PRODUCT CHANGE NOTIFICATION (PCN)

AMJE0909-0300-BKB-24
MODULAR CABLE

CHANGE NOTIFICATION: PCN 20220509_AMJE0909-0300-BKB-24

DESCRIPTION OF CHANGES:
CHANGE OF DATA SHEET
CHANGE OF DATA SHEET
New Draw.-No. ASS_7945_CArev02

AMJE0909-0300-BKB-24 OLD VERSION

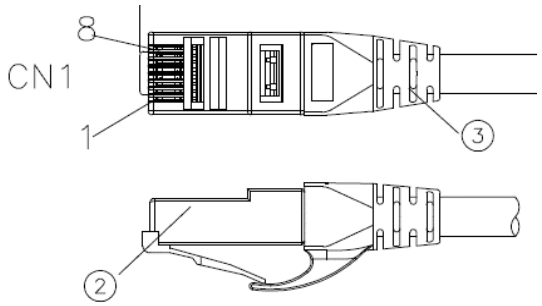
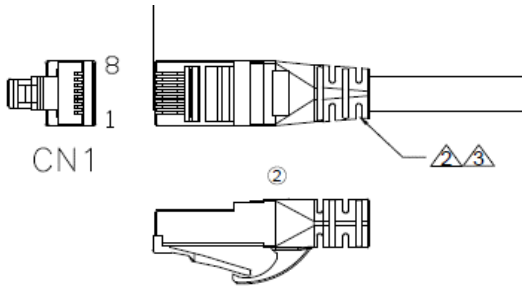
REASON FOR CHANGE:
CHANGE OF PRODUCT LOCATION
CHANGE OF PRODUCT LOCATION

③	Molding	PVC 45P Color: see order code	NA	KG
②	CONNECTOR	RJ45 8P8C two fork Short type 3u" gold plated	2	PCS
①	CABLE	CAT6 UTP (24AWG*1PR)*4+PVC OD=5.8±0.3MM Color: see order code	NA	MM
NO:	NAME	DESCRIPTION	Q'TY	UNIT

3	Molding	PVC 65P Color: see order code ②	NA	KG
2	CONNECTOR	RJ45 8P8C PLUG 3u" gold plated ②	2	PCS
1	CABLE	CAT6 U/UTP (24AWG*1PR)*4+Cross+PVC Jacket OD=5.8± 0.3MM Color: see order code ②	NA	MM
NO:	NAME	DESCRIPTION	Q'TY	UNIT

Drawing-No.
ASS 7945 CA

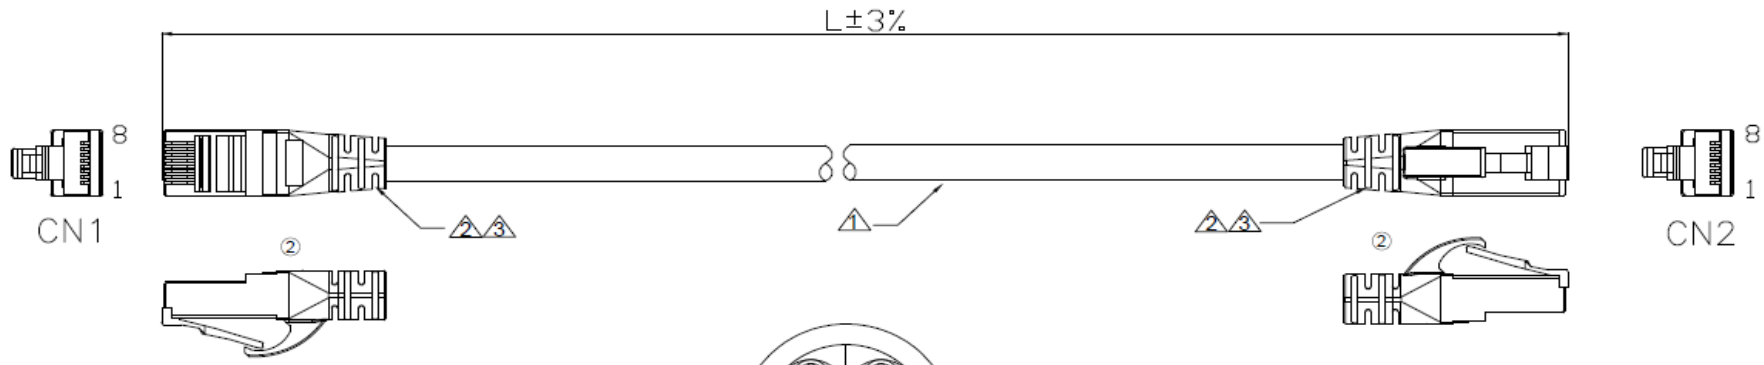
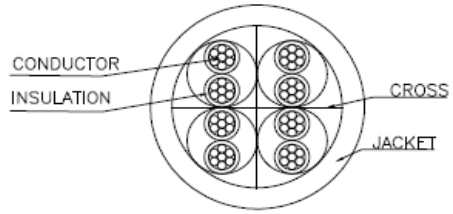
Id.	Modification	Date	Name
②	Change the plant	09.05.2022	Luca
①	Update the WSW order code	02.06.2017	Amy
⓪	Drawn	30.03.2017	Amy

NO:	NAME	DESCRIPTION	Q'TY	UNIT
3	Molding	PVC 65P Color: see order code ②	NA	KG
2	CONNECTOR	RJ45 8P8C PLUG 3u" gold plated ②	2	PCS
1	CABLE	CAT6 U/UTP (24AWG*1PR)*4+Cross+PVC Jacket OD=5.8± 0.3MM Color: see order code ②	NA	MM
